CHATHAM COUNTY PURCHASING DEPARTMENT

ADDENDUM NO. 1 TO BID NO. 13-0102-4

FOR: McQUEEN'S TRAIL - PHASE II

MCQUEENS TRAIL, PHASE II REPAIR PLAN

**SO.3**

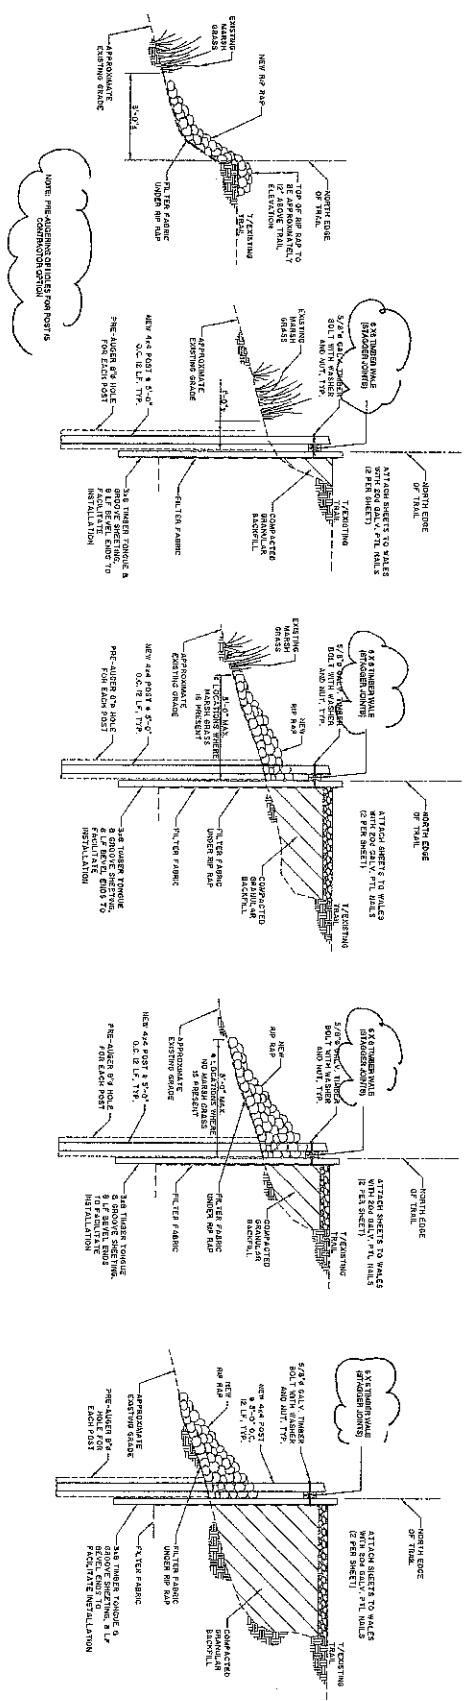
1. Timber wales size on retaining wall to be 6' x 6'. (see attached "clarification only" plan sheets)
2. Timber post for retaining wall to be 12 ft. long. (see attached "clarification only" plan sheets)

1 TYPICAL SECTION THRU TRAIL SURFACE COURSE  
 S2.2 SCALE 1/8" = 1'-0"

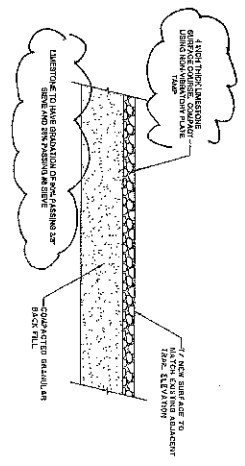
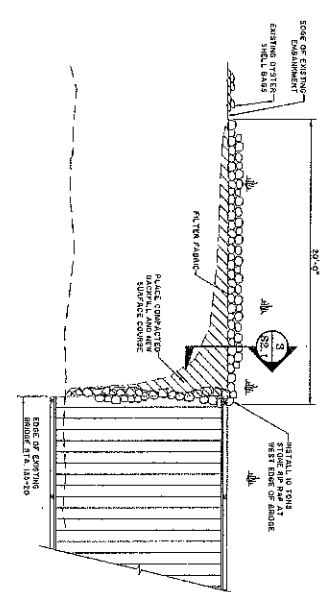
6. Surface course to be limestone aggregate with a minimum of 90% passing the 3/8 sieve and 28% passing the #8 seive. Surface course to be "plate-tamped" compacted (non-vibratory) to provide a dense compacted surface.
